Project	IEEE 802.16 Broadband Wireless Access Working Group < http://ieee802.org/16 >	
Title	Access Messages for Direct Signaling in the AAS Relay Zone.	
Date Submitted	2008-03-18	
Source(s)	Dale Branlund, Matt Volpe, Will Sun BRN Phoenix Inc. 2500 Augustine Drive Santa Clara, CA, USA 95054	Voice: +1-408-572-9703 Fax: +1-408-351-4911 dbranlund@brnphoenix.com
	John Norin, Robert Popoli The DIRECTV Group, Inc. 2250 East Imperial Hwy El Segundo, CA 90245	Voice: +1-310-964-0717 Fax: +1-310-535-5422 john.norin@directv.com
Re:	Working Group Letter Ballot Recirc #28b, Technical Comments and Contributions regarding IEEE Project P802.16j; Draft Amendment P802.16j/D3.	
Abstract	This contribution describes the Direct Signaling messages transmitted in the access channel of the AAS Relay Zone to accomplish ranging and bandwidth request and grant.	
Purpose	This document provides the necessary access messaging to properly accomplish ranging and bandwidth request/grant within the AAS Relay Zone for Direct Signaling mode of operation.

Access Messages for Direct Signaling in the AAS Relay Zone

Figure 2. Transmitter Signal Processing

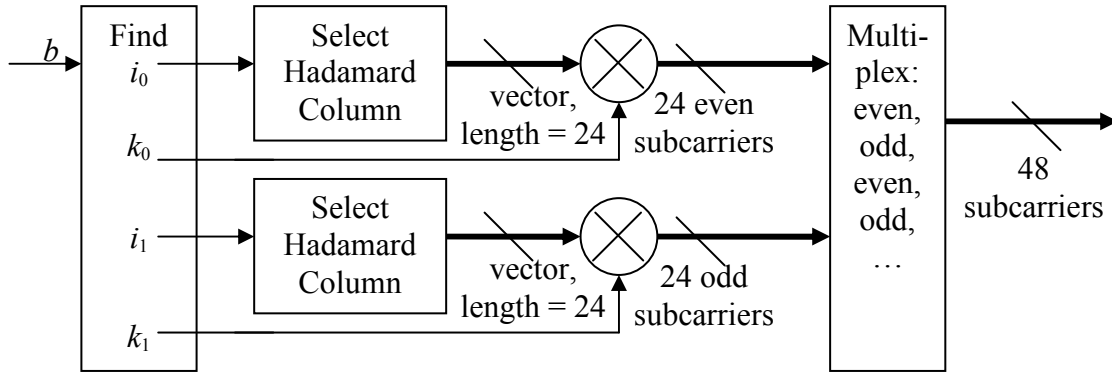
Insert Figure xxxa (.16e)/Figure xxxa (Rev2) as indicated:

The signal processing for the transmitter is shown in Figure 1. b represents the DLI codeword and ranges from 0 to 2303. It is then broken down into two groups of 24. i_0 selects one of 24 Hadamard columns for the first group and ranges from 0 to 23. k_0 selects the BPSK modulation for the first group. i_1 selects one of 24 Hadamard columns for the second group. k_1 selects the BPSK modulation for the second group. The Hadamard(24) matrix is as follows:

The first group of 24 sub-carriers is multiplexed with the second group of 24 sub-carriers. If the indices to the sub-carriers of a slot were numbered from 0 to 47, the even numbered sub-carriers come from the first group of 24 and the odd number sub-carriers come from the second group of 24. The first sub-carrier of the slot is $H(0, i_0) k_0$, the second, is $H(0, i_1) k_1$, the third is $H(1, i_0) k_0$, the fourth is $H(1, i_1) k_1$, etc., where zero-based indexing is assumed when accessing the Hadamard matrix, $H(n, i)$.
